Access Compliance Report

Public Rights-of-Way

(Curb Ramps)

Intersection ID: 44309	Main Street: LINDA_VISTA_LN	Cross Street: OLIVIA_DIANE_LN	Location: SE
ADA ID: 60B465FF8E1C	Ramp Type: PerpDiag	Initial Pass/Fail: Fail	Overall Compliance: No
Severity Score: 10			
Codes/Mitigation Info/Possible Solution		Field Measurements/Component Compliance

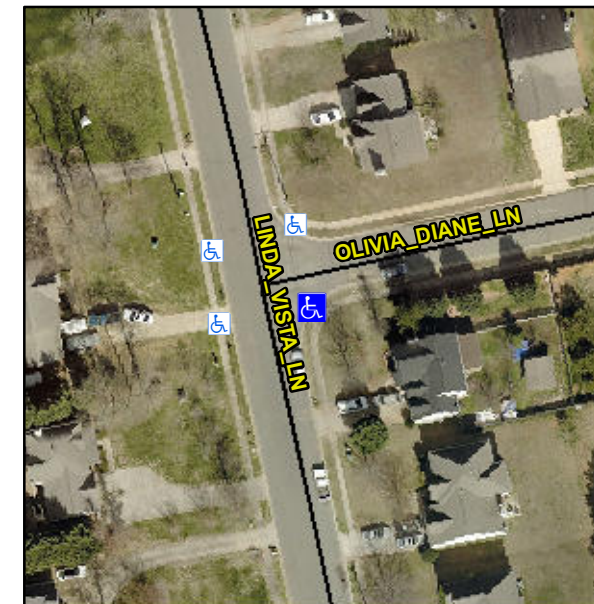
Remove & Replace Curb Ramp With Two New Directional Ramps or Equivalent.

Not Found, R304.5.1, R304.5.3

Compliance	Description	Data	Compliance	Description	Data
N/A	Ramp Length (in)	47.5	Yes	Ramp Slope (%)	6.7
No	Ramp Width (in)	39.0	No	Ramp XSlope (%)	2.7
N/A	Flare Type LT	N/A	N/A	Flare Type RT	N/A
N/A	Flare Slope LT (%)	N/A	N/A	Flare Slope RT (%)	N/A
N/A	Flare Traversable LT?	N/A	N/A	Flare Traversable RT?	N/A
N/A	Landing Length (in)	N/A	N/A	DWS Provided?	N/A
N/A	Landing Width (in)	N/A	N/A	DWS Contrast?	N/A
N/A	Landing Slope (%)	N/A	N/A	DWS Length (in)	N/A
N/A	Landing X Slope (%)	N/A	N/A	DWS Full Width?	N/A
N/A	Landing Curb? (Y/N)	N/A	N/A	DWS Offset (in)	N/A
N/A	Shared Landing?	N/A			
N/A	Gutter Ponding?	N/A	N/A	Gutter Slope (%)	N/A
N/A	Gutter Lip Ht (in)	0.5	N/A	Gutter X Slope (%)	N/A
N/A	Painted X Walk1?	No	N/A	Painted X Walk2?	No
	X Walk 1 Direction	To N		X Walk 2 Direction	To W
N/A	X Walk 1 Width (in)	N/A	N/A	X Walk 2 Width (in)	N/A
	X Walk 1 Slope (%)	0.1		X Walk 2 Slope (%)	0.8
	X Walk 1 X Slope (%)	0.1		X Walk 2 X Slope (%)	0.6
